CADENCE 21

Recommendation Meeting #2

111 21st Avenue Seattle, WA 98122

SDCI Number: 3025782

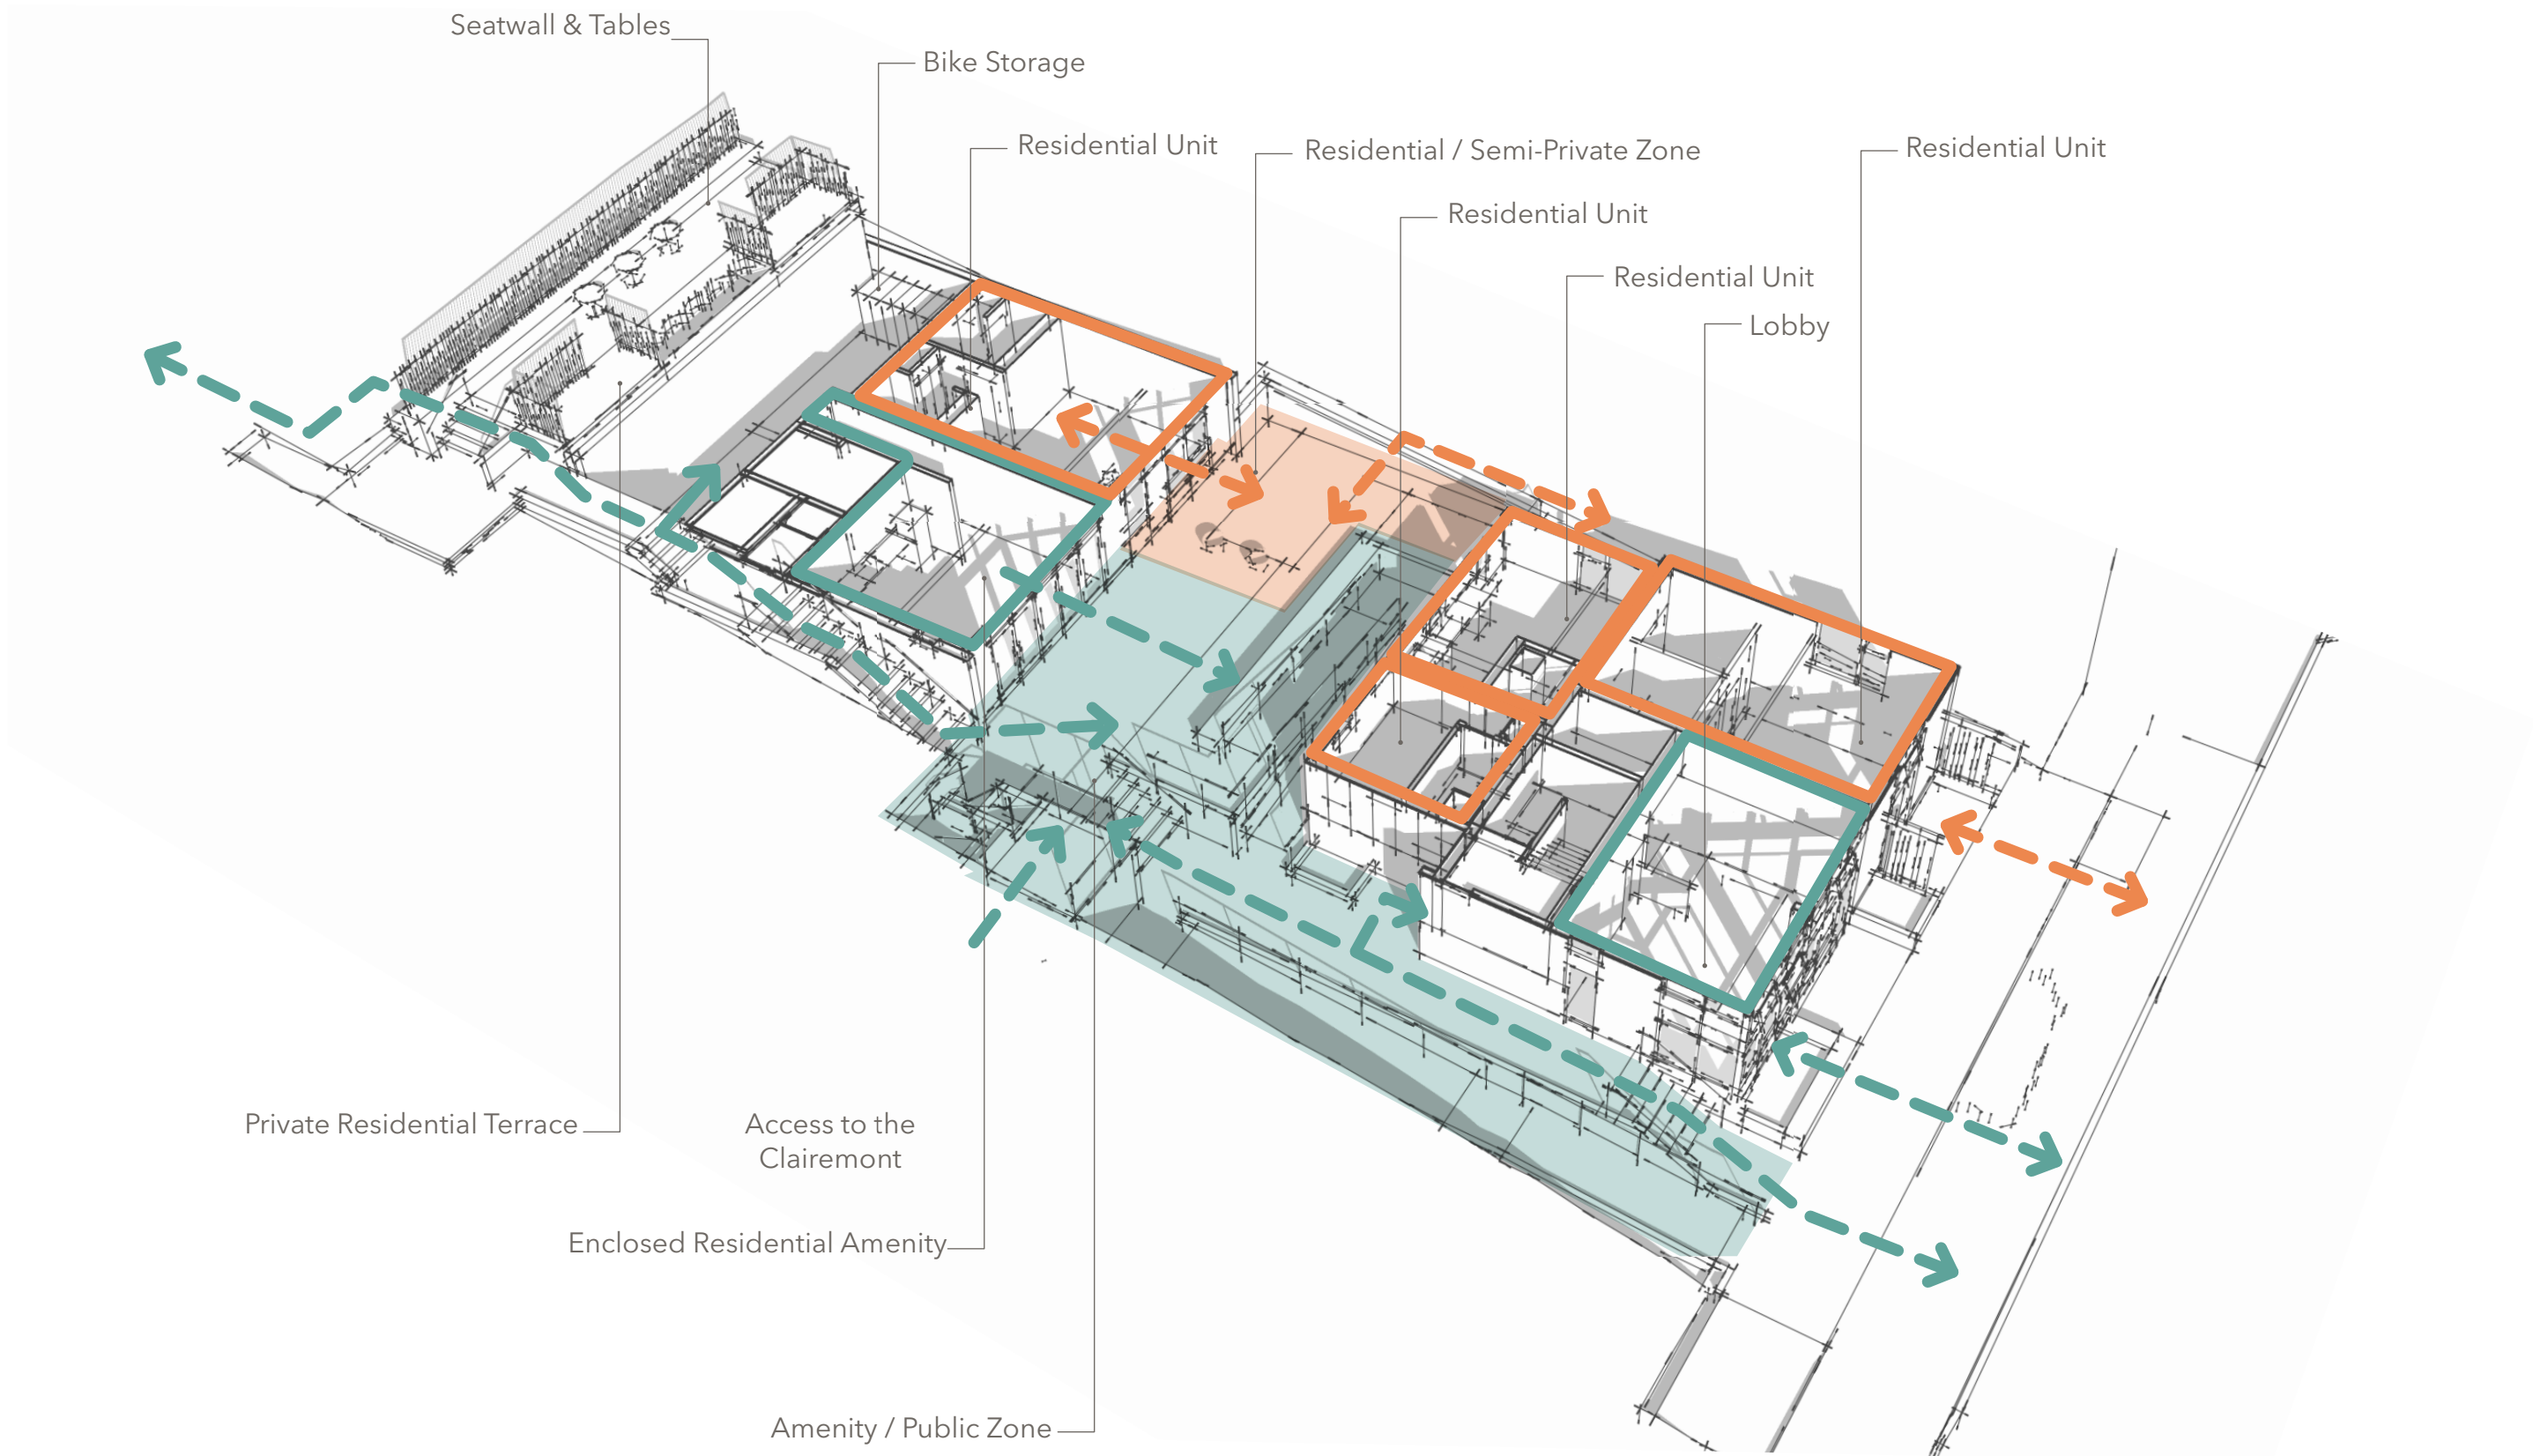
- 1 Revisit the exact relationship of hardscape to proposed uses. The Board suggested that the design team continue with decking for residential portions and masonry type treatment for non-residential portions. The Board was amenable to different configurations that expanded the decking and residential portions to the seated wall within the center courtyard. DC1-A-2. Gathering Places
- 2 Provide a thoughtful treatment of the landscaping edge along the south edge of the circulation path. DC4-D-1. Choice of Plant Materials
- 3 Update elevations and material application, removing the corner boards treatment as shown on page 11 of the Recommendation packet. DC2-B-1. Façade Composition, DC4-A Exterior Elements and Finishes

- A Accessible Unit
- A Decking (Residential Units)
- B Permeable paver (Public Entry)
- C Climbing Hydrangea (*Hydrangea anomala petiolaris*)

Setback Average Diagram

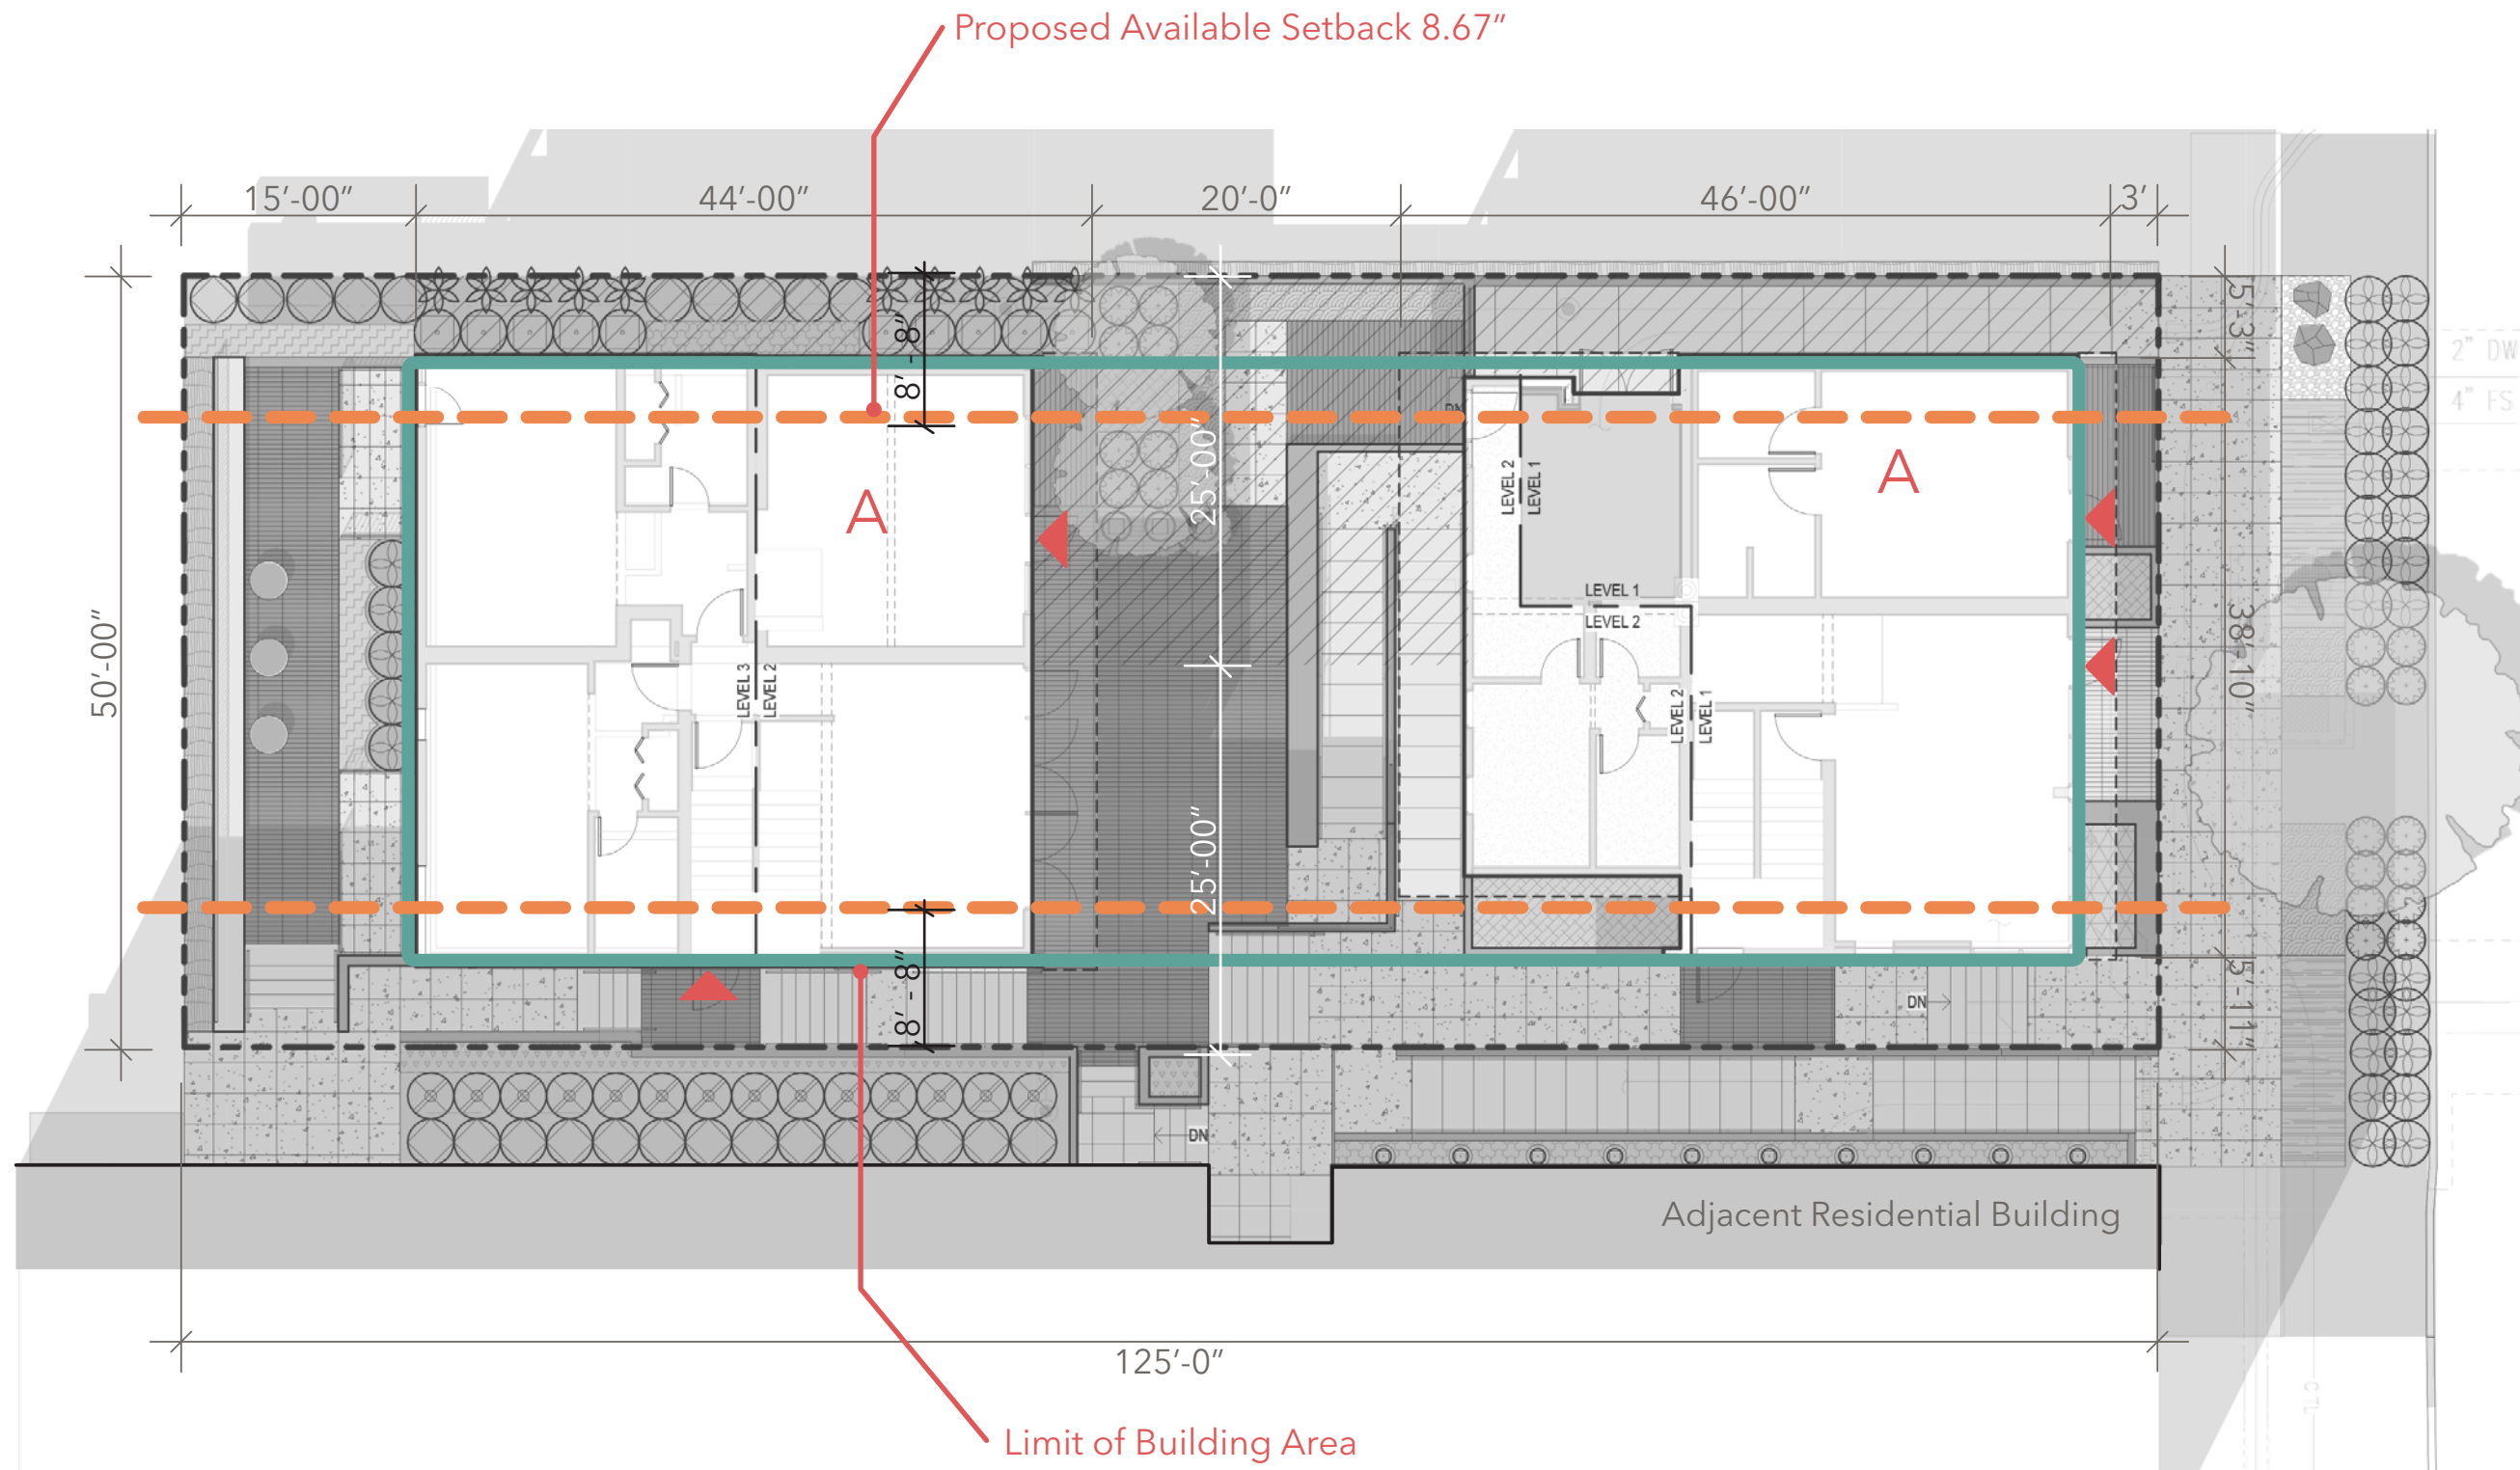
Departure 3: Setback Average

- Per Table A, side yard setback must average 7'

- Side yard averaging to include open space between buildings

- As the project is foregoing a significant development area between the structure to create a usable open space, we propose this area is included in the averaging of the setback
